LEED for New Construction
Version 2.2
Reference Guide
First Edition
October 2005

Errata posted

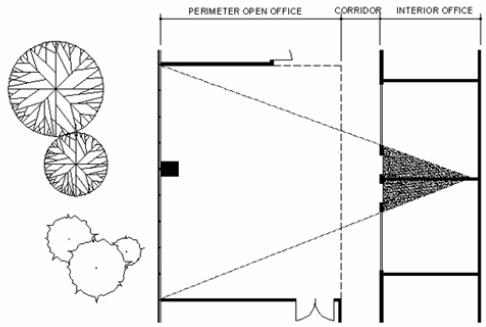
EQc4.1	333	In the bottom-most section of Table 1 (the one with 3 rows of data), replace “Sealants” with “Sealant Primers” (the section above it addresses the sealants).
EQc3.18	384	Figure 1 is missing in the print version of the Reference Guide, but not the
